March 9, 2023
93219-10

LL Bean – Freeport, ME
LL Bean, Justin's Way Mechanical Penthouse

On behalf of LL Bean, we are submitting materials for the mechanical penthouse for the Retail Store. The penthouse's location is at the furthest building corner abutting Justin's Way and the loading and service yard for the campus. We appreciate the Project Review Board's attendance at the recent site walk. We hope the context of the surrounding structures and back-of-house operations for LL Bean further highlights the appropriateness of the location for this necessary enclosure.

L1 JUSTIN'S WAY ELEVATION - PERMITTING

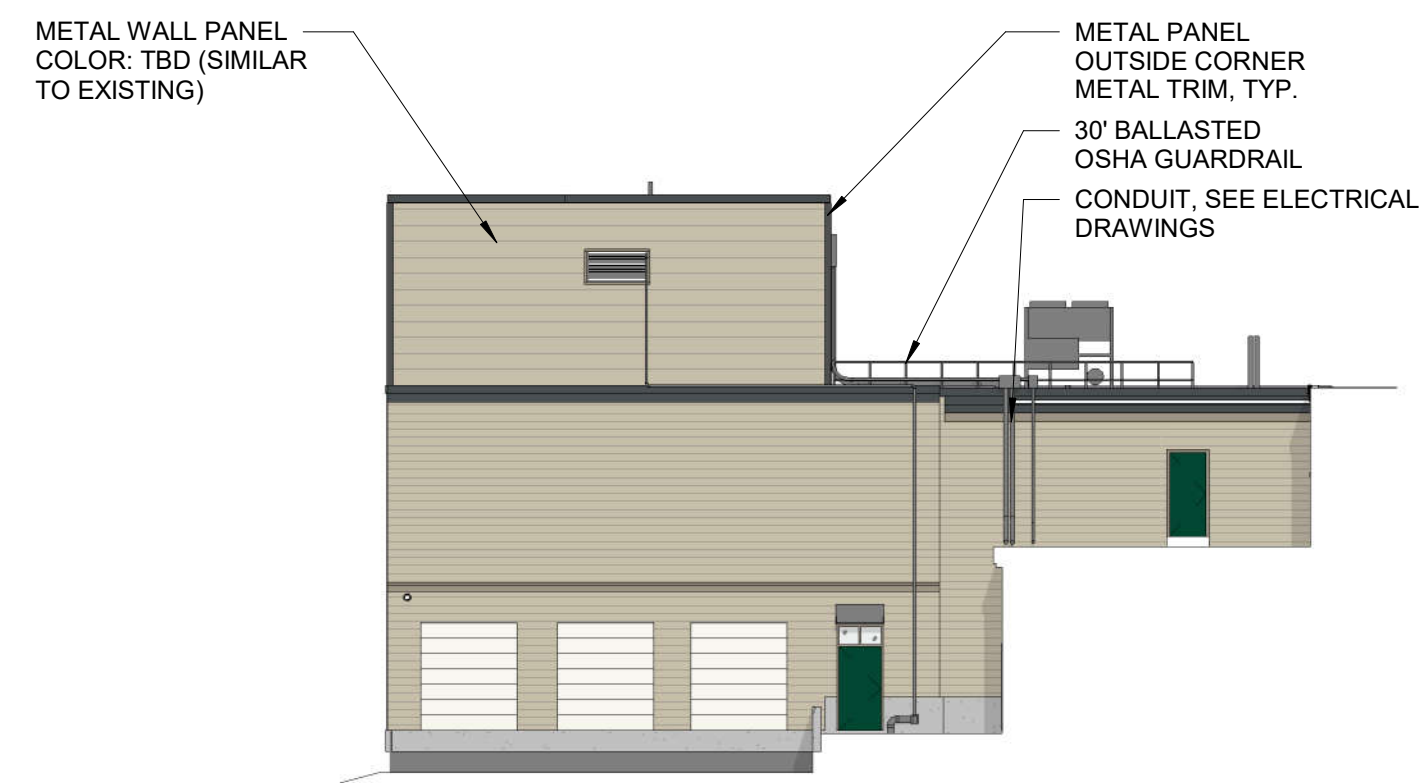
Based on feedback, the materials selected for the penthouse have been changed. Originally specified as a dark bronze metal enclosure to hide the penthouse, the proposed materials are now comprised of a

horizontal metal panel in a color that matches the existing structure. The panels consist of a smooth panel with a reveal every 8" to mimic clapboard siding. Further, decorative trim and roof edge has been added to coordinate with the existing Justin's Way elevation façade.
